REQUEST

Current Zoning: NC (neighborhood center), N1-D (neighborhood 1 - D), and O-6(CD) (office, conditional)
Proposed Zoning: CAC-1 (EX) (community activity center 1, exception)

SUMMARY OF PETITION

STAFF RECOMMENDATION

The site plan accompanying this petition contains the following provisions:

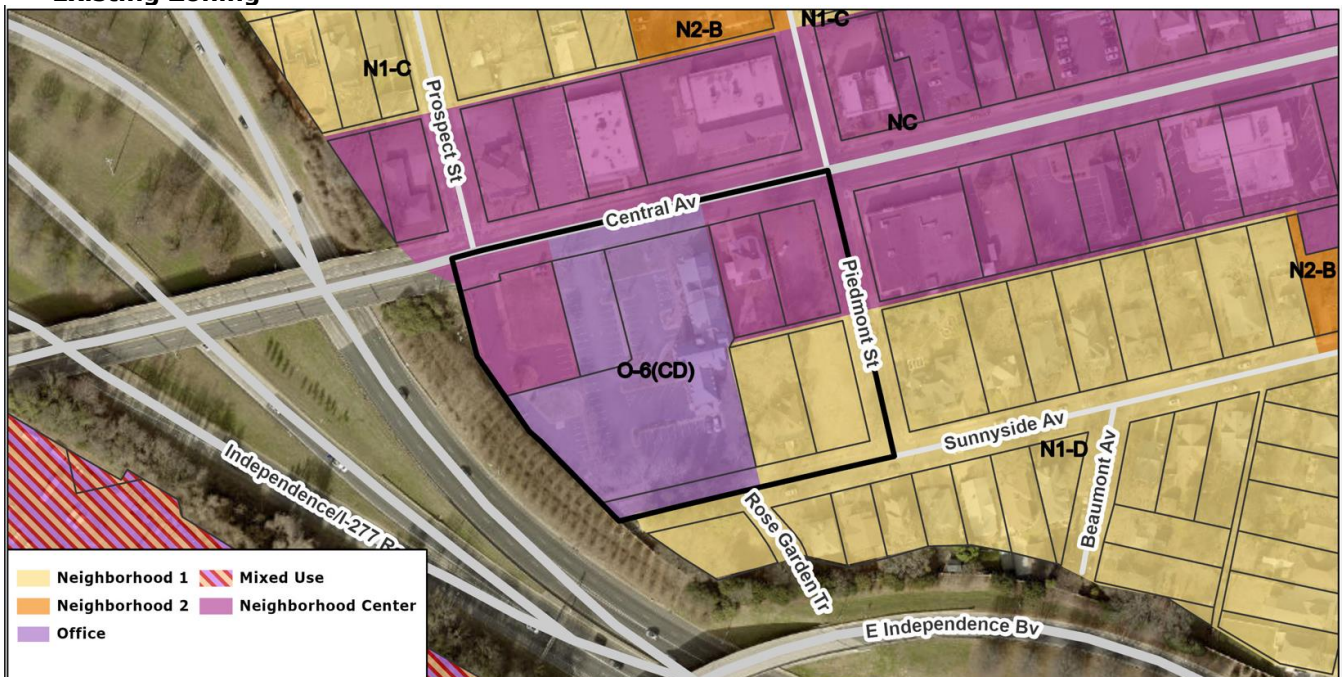
1. Under the public amenity EX benefits regarding sewer line relocation add the following text, "The relocated sanitary sewer shall not be placed within 10' of the edge of the CATS Silver Line infrastructure (as shown on rezoning plan) or within 10' of any permanent structure and will be encased per CLT Water guidelines. Design work for the relocated sewer line will be coordinated and reviewed with Charlotte Water and CATS."

2. Clarify that the minimum of 1,500 square feet of non-residential uses will be for retail uses unrelated to the multi-family development.

3. Clarify in the conditional notes and building height inset map that the height exceptions requested include a very small piece of the building within the 100' to N1 height plane zone as requesting 85' rather than 50' at the southwestern edge of the site. There are a total of three height exceptions being requested, one for where the site is within a 100' of N1 on the southwestern corner of the site, one for where the site is within 200' of N1 along the western edge of the site, and one for where the site is within 200' of N1 at the northeastern corner of the site.

4. Revise the site plan to clearly show the limits of Silver Line ROW. The legend indicates that this should be shown in blue but it is not appearing on the plan. Refer to CAD files from CATS to show the limits of this area.
